**SUBJECT:** NuScale Power, LLC Response to NRC Request for Additional Information No. 259 (eRAI No. 9138) on the NuScale Design Certification Application

NuScale Response to NRC Request for Additional Information eRAI No. 9138

### **NRC Question No.: 19-33**

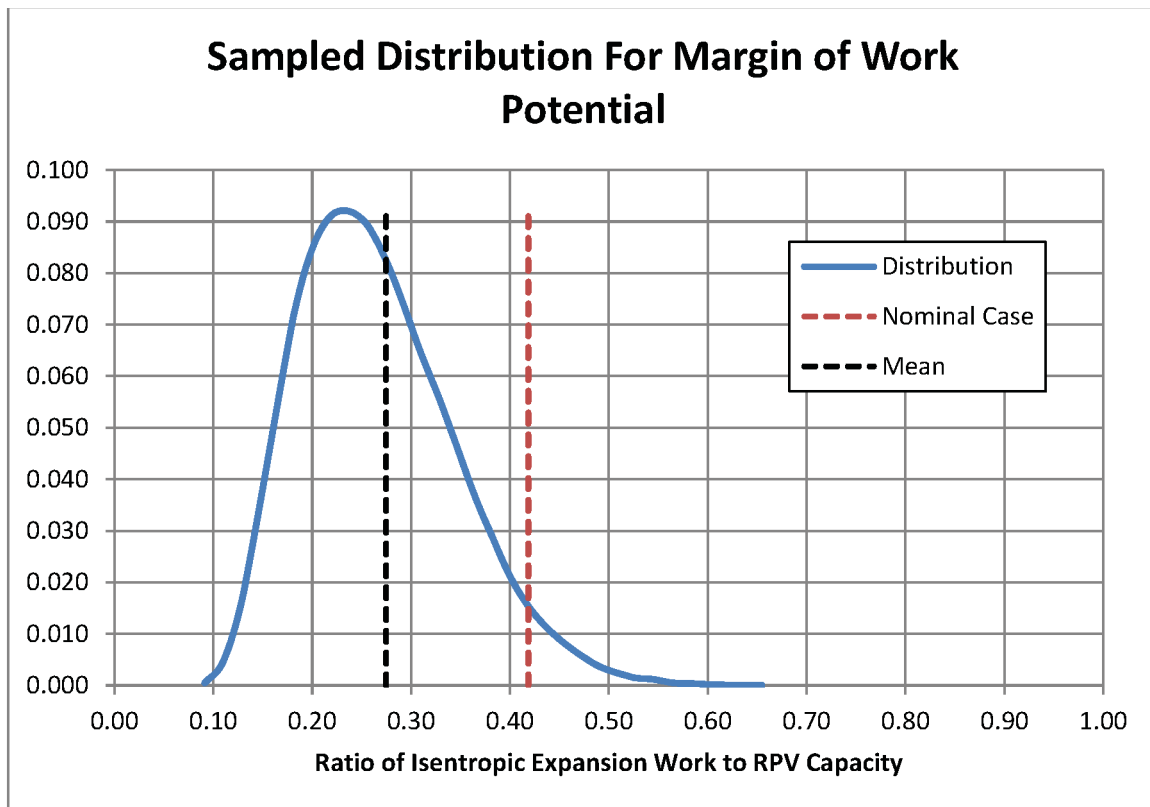
- b. For in-vessel steam explosion, the applicant’s analysis addressed different initial reactor coolant system (RCS) hole sizes and emergency core cooling system (ECCS) failure modes by using as input the MELCOR predictions for sequences with different initial RCS hole sizes and ECCS failure modes. However, the NRC staff could not find where the applicant’s analysis addressed uncertainties in the modeling of physical phenomena in its MELCOR simulations, such as uncertainties in in-vessel melt progression modeling (e.g., modeling of core heat-up, collapse, and formation of molten pool). Such uncertainties have

the potential to result in a different energy of corium relocating to the water in the RPV lower plenum. An example of consideration of such uncertainties is given in “State-of-the-Art Reactor Consequence Analyses (SOARCA) Project: Sequoyah Integrated Deterministic and Uncertainty Analyses,” Draft Report, April 2016 (ADAMS Accession Number ML17156A255). The staff requests additional information to understand how the applicant’s analysis addressed uncertainties in the modeling of physical phenomena.

To inform the uncertainty analysis for in-vessel FCI, input values to the thermodynamic FCI model are acquired from each MELCOR accident simulation; this range of values is then used to develop a probability distribution for each input. The minimum and maximum observations are assumed equivalent to the minus and plus one standard deviation values of the distribution, respectively, and a uniform distribution is assumed between those values. A lognormal distribution is assigned for the tails of each input parameter distribution to allow for the sampling of extreme values not predicted within MELCOR simulations. Random samples for each input are then acquired by Monte Carlo sampling and used to evaluate the Hicks-Menzies model for the expansion work performed on the RPV. The result of each sampling iteration is a comparison of the expansion work to the capacity of the RPV, presented as a ratio between the two (note that a ratio greater than 1.0 constitutes failure).

The in-vessel FCI uncertainty analysis results are reproduced in the following figure. In the figure, the sampled distribution is in blue, the mean value of the sampled distribution is the black dashed line, and the value assuming a bounding combination of input parameters from MELCOR is the red dashed line. Based on the maximum sampled ratio (approximately 0.67), significant margin exists between the RPV capacity for coolant expansion and expansion work determined by the Hicks-Menzies model.

FSAR Section 19.2.3.3.5 has been modified to include additional detail related to consideration of uncertainty in the modeling of in-vessel FCI.
